REDLINE REVISION NO. 5  
MD 175 AT DISNEY ROAD; REVISED POLE LOCATIONS IN THE NW QUADRANT

STATE OF MARYLAND  
DEPARTMENT OF TRANSPORTATION  
STATE HIGHWAY ADMINISTRATION  
OFFICE OF TRAFFIC & SAFETY  
TRAFFIC ENGINEERING DESIGN DIVISION  
MD 175 (ANNAPOLIS ROAD) AT  
26TH STREET /DISNEY ROAD  
FORT MEADE, MD

MOT PHASE 2 - TRAFFIC SIGNAL PLAN

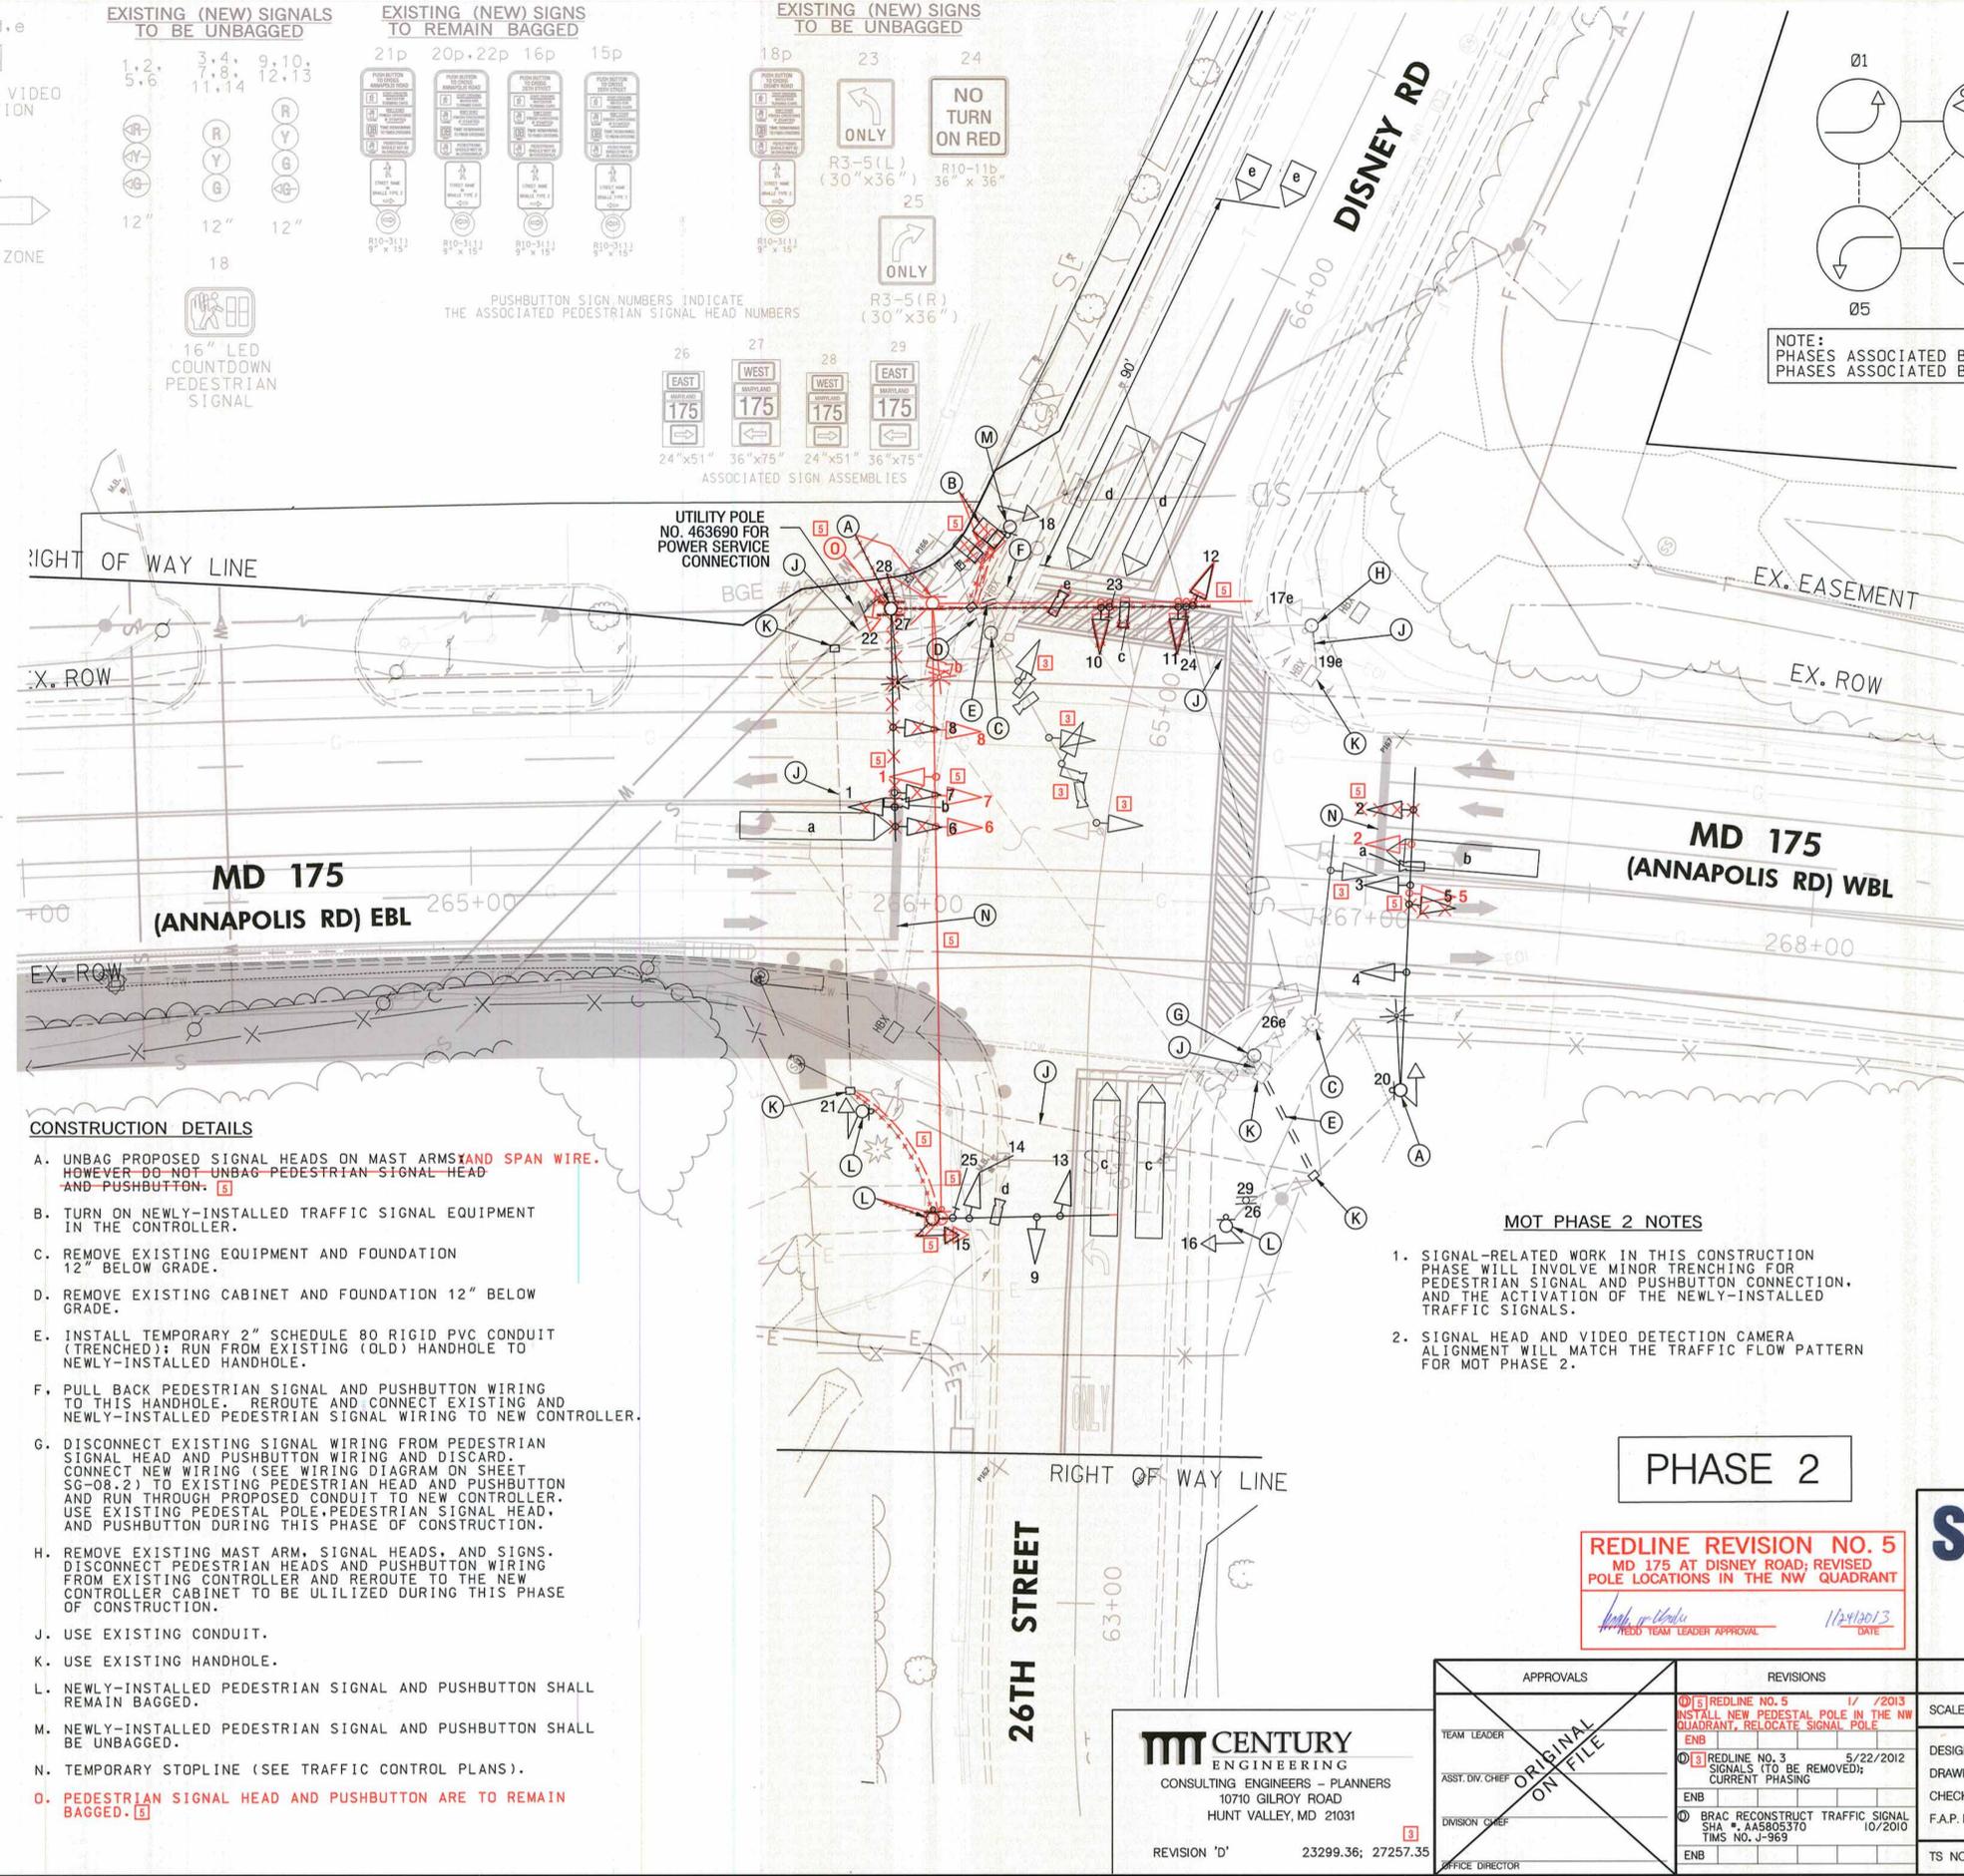
APPROVALS	REVISIONS
YEAR LEADER	REVISION NO. 5 1/7/2013 INSTALL NEW PEDESTAL POLE IN THE NW QUADRANT, RELOCATE SIGNAL POLE
ASST. DIV. CHIEF	REVISION NO. 3 5/22/2012 SIGNALS (TO BE REMOVED); CURRENT PHASING
DIVISION CHIEF	BRAC RECONSTRUCT TRAFFIC SIGNAL SHA # AA5805370 10/2010 TMS NO. J-969
OFFICE DIRECTOR
